### CUP10-00059 & CVA10-00032 / Persimmon II, LLC

### Planning Division Staff Report

<b>File Number</b>	CUP10-00059 & CVA10-00032
<b>Applicant</b>	Persimmon II, LLC / Rudy Kadlub
<b>Property Address</b>	1511 W. Bannock Street
<b>Public Hearing Date</b>	November 1, 2010
<b>Heard by</b>	Planning and Zoning Commission
<b>Analyst</b>	Susan Riggs
<b>Checked By</b>	Cody Riddle

**1 SITE & LANDSCAPE PLAN**  
SCALE 1/8" = 10'-0"

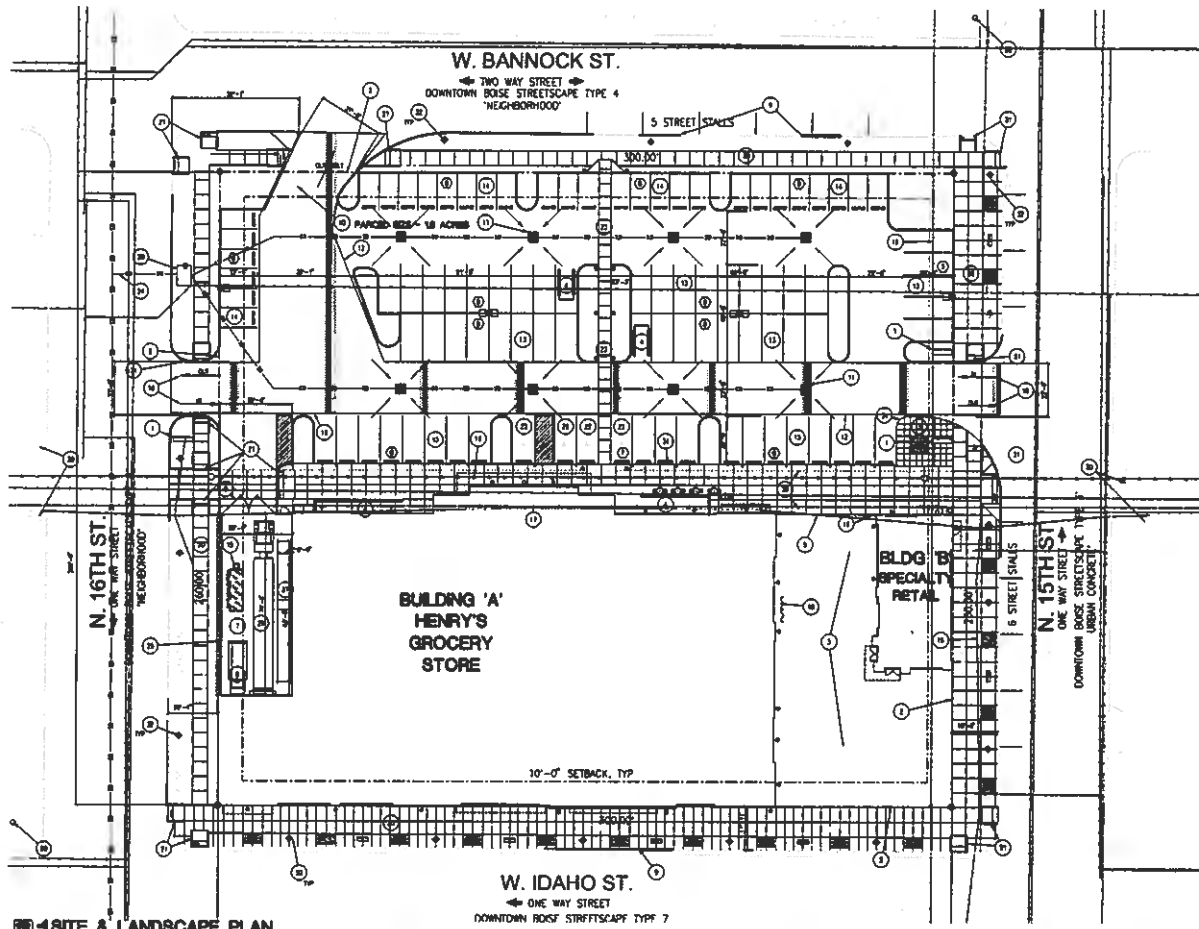
Staff is somewhat concerned with the layout and configuration of the project. The site is located in the Downtown Planning Area of the Comprehensive Plan. *Policy 8.1.17.13 and numerous others* promote the principles of new urbanism and pedestrian orientation in downtown development. The project includes elements more commonly associated with suburban retail development. It is a single-use (retail) development with a large surface parking lot and the primary building does not include an entrance along Idaho Street. However, staff recognizes that unless part of a larger mixed-use project, a grocery store requires some amount of surface parking. Staff has worked extensively with the applicant who has explored numerous design alternatives to ensure the project is appropriately integrated with surrounding uses, and those reasonably expected to develop. Options included orienting the building to Idaho Street, aligning the service drive entrance with the existing alley and creating a pedestrian promenade, or providing an additional building entrance to the retail plaza on the southeast corner of the site.

After discussing the need for a continuous bike lane and the alignment concerns with ACHD's Traffic Services, staff recommends the applicant reconstruct Bannock Street with a 46 foot back-of-curb to back-of-curb street section to match the curb line east of 15<sup>th</sup> Street. This street section will accommodate parking on the north side, two bike lanes and two travel lanes. Between the curb and the right-of-way lines will be a six foot planter with root-barrier, trees, a six foot sidewalk, and space for a two foot wall. Another option is an eight foot planter with trees and no root-barrier, and a six foot sidewalk. This would leave no separation between the site's parking and the sidewalk.

This proposal removes the five on-street parking stalls abutting the site shown on the submitted site plan. Staff supports bike lanes on Bannock Street over five parking stalls.

The applicant is requesting to construct the parking to the property line along 15<sup>th</sup>, 16<sup>th</sup>, and Bannock Street. The applicant has proposed a five foot landscape setback in the right-of-way on 16<sup>th</sup> Street, a two foot-eight inch planter along Bannock Street and no landscaping along 15<sup>th</sup> Street. Staff believes some relief to the parking setbacks are justified as the parking is separated from 15 to 20 feet from the street with extended sidewalks and planting strips. A condition of approval requires the parking lot to be screened with a five foot landscape buffer along 15<sup>th</sup> and 16<sup>th</sup> street and a two foot high screen wall and/or fencing and landscaping along Bannock Street.

1. Compliance with plans and specifications submitted to and on file in the Planning and Development Services Department dated received September 28, 2010 (applications) and October 14, 2020 (all drawings) except as expressly modified by the Design Review Committee, staff, or the following conditions:
2. **Planning**
  - a) Provide a five foot landscape buffer adjacent to the parking lot on 15<sup>th</sup> Street, similar to the one on 16<sup>th</sup> Street.

- b) Provide a two foot tall screen wall and/or fencing and landscaping along Bannock Street to help screen the parking lot from Bannock Street.
- c) Building B shall support a use or uses that activate the plaza such as a restaurant, coffee shop or pedestrian oriented retail intended to support residents and employees in the area.
